**Subject: Comment RIN 3150-AH24 Rulemaking on ASME Seismic Piping Requirements**

**ASME Position Paper on  
Proposed USNRC Rule Making Affecting the  
ASME Boiler and Pressure Vessel Code, Section III, Division 1  
Subsection NB-3600 Subsection NB-3228 , Subsection NC-  
3600 and Subsection ND-3600 Piping Design Rules**

**Developed for the  
ASME BPVC Subcommittee on Nuclear Power (SC III)  
by Members of the  
ASME BPVC Subgroup on Design (SCIII)**

**Figure 4.1  
Ratio of OBE g Levels to SSE g Levels  
Re-Inforced Concrete Reactor Building**

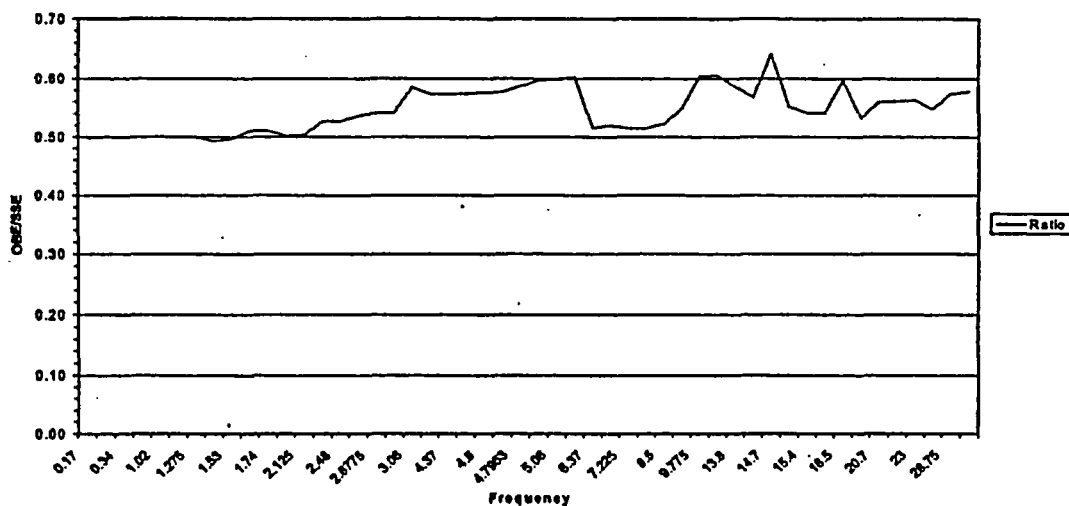
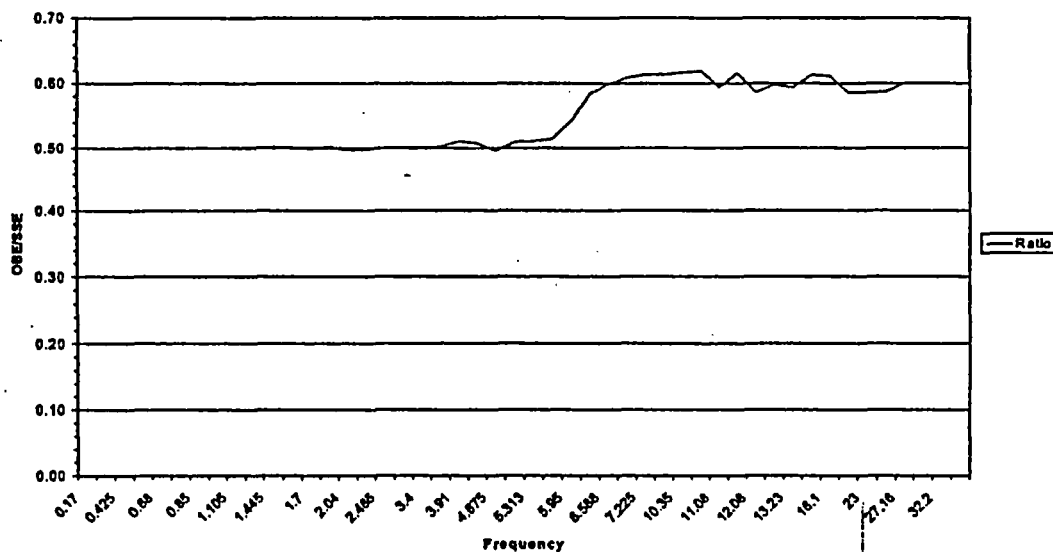
From a review of Figures 4.1 and 4.2 it can be seen that in one case for all frequencies above 3 Hz the ratio of the OBE g levels to the SSE g levels is .6 or greater. For the second case it can be seen that for all frequencies above 6 Hz the ratio of the OBE g levels to the SSE g levels is .6 or greater. Therefore for a majority of the piping response, including the ZPA or "rigid" response, the OBE input g level will be .6 or greater of the SSE. For static analysis where the input is a factor times the peak g's of the AFRS the OBE input g level will almost always be .6 or greater of the SSE. Therefore, for the carbon steel and a large majority of the Stainless Steels shown in Tables 4.1 through 4.3 the design will be controlled by the OBE.

Fig. 2-1 FEM model of shell element for Test #37

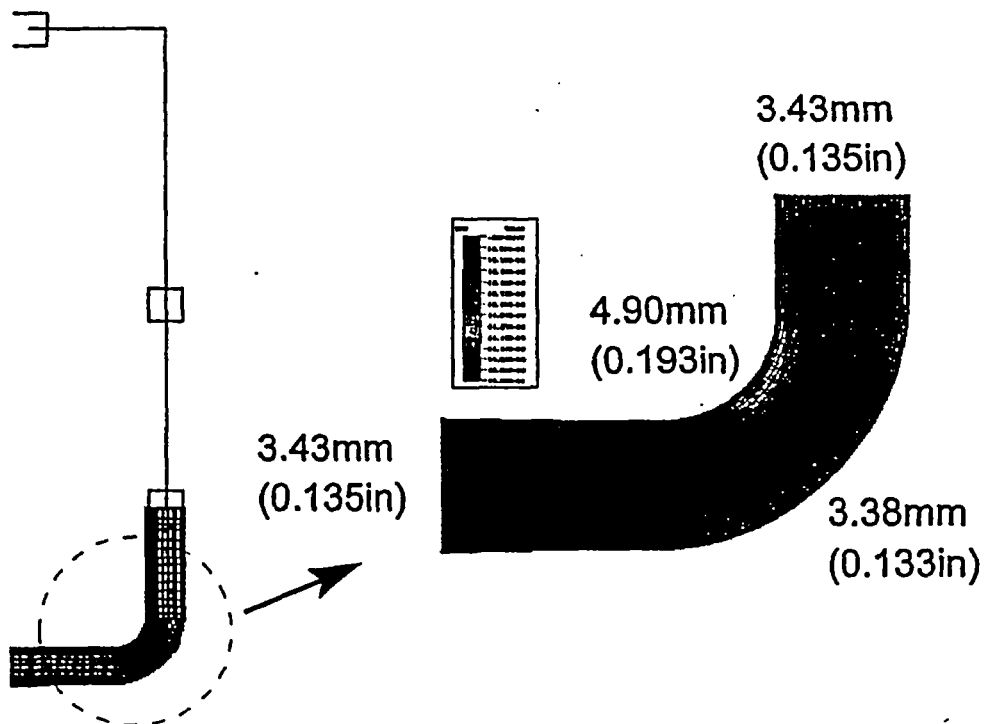
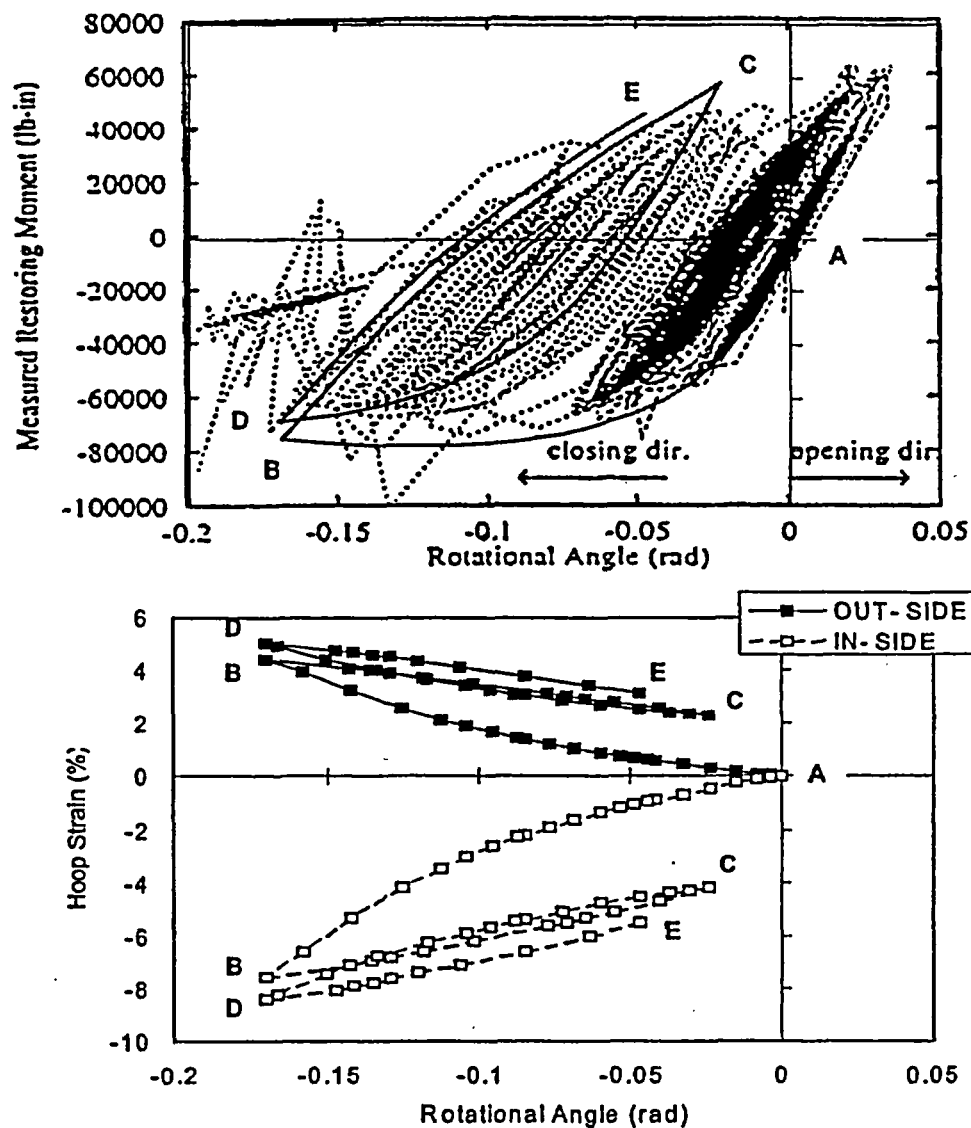
NRC evaluated the strain rate test 37, run5 as 2/sec. The Japanese Seismic Team (JST) is convinced that this is not correct.

According to our analysis for test#37, Run5 as shown in Fig. 2-1,2,

- 1) Max peak strain at Run5 is 8% but it is not strain amplitude.
- 2) Strain amplitude at maximum strain position on Run5 ( $M_{UD}$  condition) is 2% (Range is 4%), not 8%
- 3) Peak strain rate is 0.5/sec. ( $=0.02 \times 2 \times 3.14 \times 4\text{Hz}$ , referred the NRC equation)  
(Motion of component is assumed as sinusoidal and strain behavior is also assumed as sinusoidal)
- 4) Average strain rate is reduced to 0.32/sec. ( $=0.04/0.125$  for 4Hz; same assumption as NRC)

0.11/sec. ( $=0.04/0.357$  for 1.4Hz; Natural Freq. of #37)

Combination of peak strain rate and peak strain is too much conservative. Actually, strain becomes zero at peak strain rate and strain rate becomes zero at peak

Fig.3-10 □ Hoop Strain Distribution Corresponding to 6.5Sm □ Fictitious □  
□ Analysis Result □

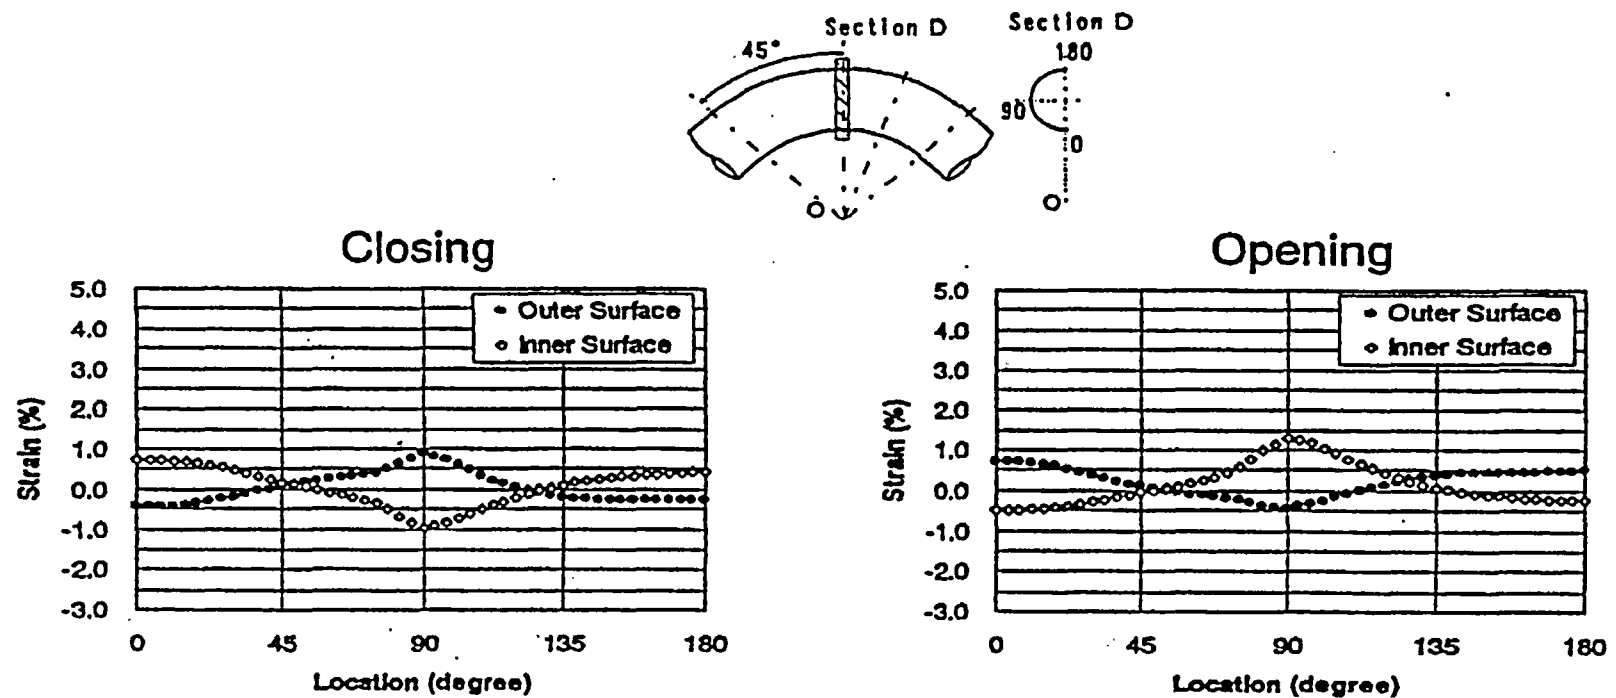
In-plane bending tests of elbows shown in Fig.3-1 were analyzed. In analyses, reversing bending loads (displacement) correspond to 6.5Sm (fictitious) and 10.5Sm (fictitious) were applied to the elbow model, respectively. The load of 6.5Sm corresponds to 2.0Sm (fictitious) for SAM (seismic anchor motion stress limit of amplitude and Bs stress index instead of range and C2 <sup>(\*)</sup>)plus 4.5Sm (fictitious) for inertia load.

Strain range under 6.5Sm (fictitious) is 0.023 (2.3%) as shown in Fig.3-10 &11. Accordingly, strain rate for 4Hz is 0.18/sec (see Table 3-2).

Figure 14 Stress strain hysteresis loop  
(Stainless steel, SUS304TP, RT)  
Upper : 1st block  
lower : 15th block

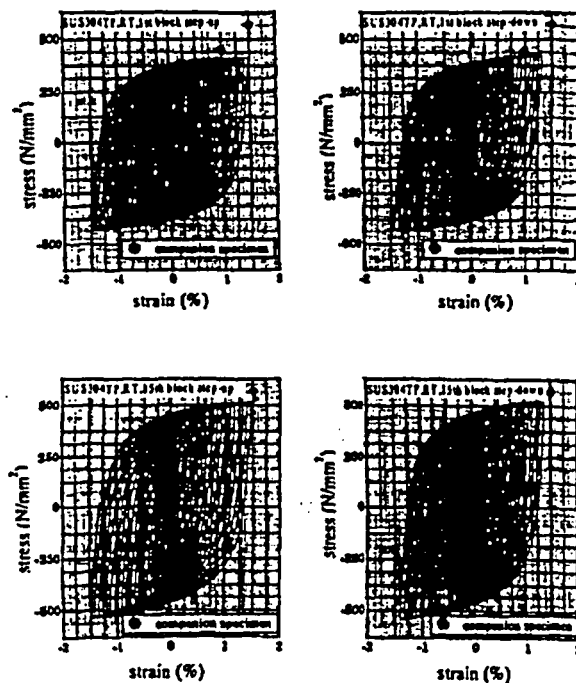
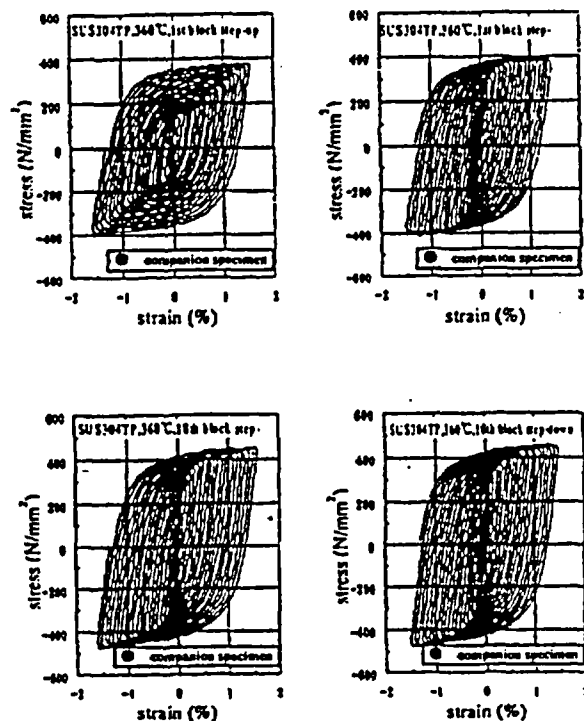
For a typical stainless steel, the same comparison can be made. Compare Appendix 4, Figure 4 (RT) to Figure 5 (300°C) for the 15<sup>th</sup> and 18<sup>th</sup> blocks, respectively. We see about 500 N/mm<sup>2</sup> (73 ksi) at 1.5-% strain at RT, and about 425 N/mm<sup>2</sup> (62 ksi) at elevated temperature, or a reduction

of about 15%. This is essentially the same reduction in  $3 S_m$  over that range. For RT to 500°F, the change in  $3 S_m$  is from 60 ksi to 51 ksi, or exactly 15%. At 300°C/570°F, the Code reduction would therefore be greater than 15%. Thus, the effect of temperature on  $M_{UD}$  is reasonably accounted for in the Code methodology.

**Fig. 1 Moment vs. Rotation Based on Load-Line Displacement for IPIRG Experiments 1.2-4 and 1.2-6**

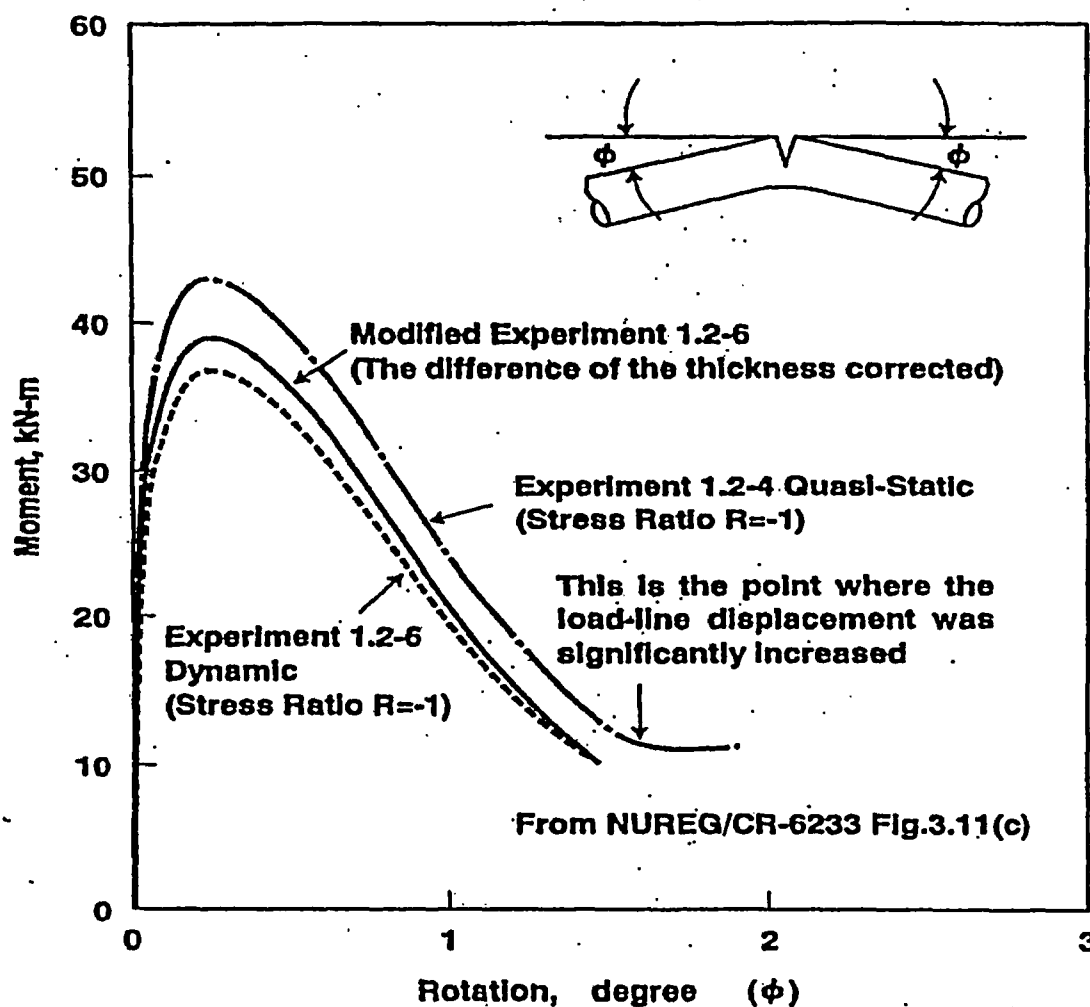
In Fig.1, the solid line and the one dotted chain line show the moment in tension side vs. crack rotation relations obtained by the dynamic cyclic and the quasi-static pipe fracture tests, respectively.
